Urgent Field Safety Notice
Programmer Software Update
Supporting the Micra™ Transcatheter Pacing System

Model
2090 CareLink™ Programmer
29901 Encore™ Programmer
CareLink Network Application Software 2491

January 2019

Medtronic reference: FA856

Image 1

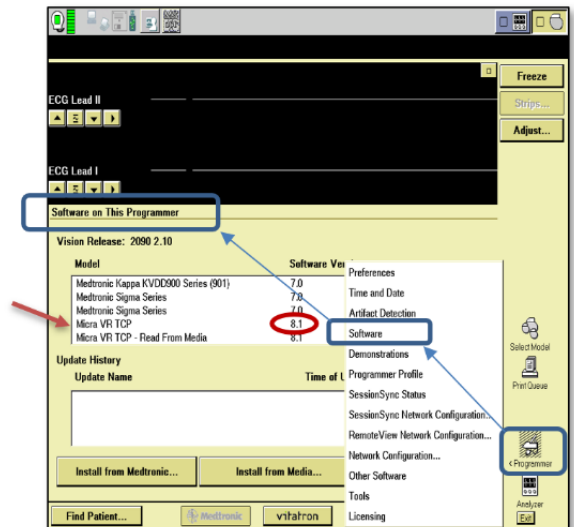
Software Installation History Screen

Correct software: Micra VR TCP version 8.1 (or higher)

- Select Software (see image 1)
- Scroll through the list of available Software Models in the top selection box until you locate the Micra selection
- Verify the Software Micra VR TCP Version is 8.1
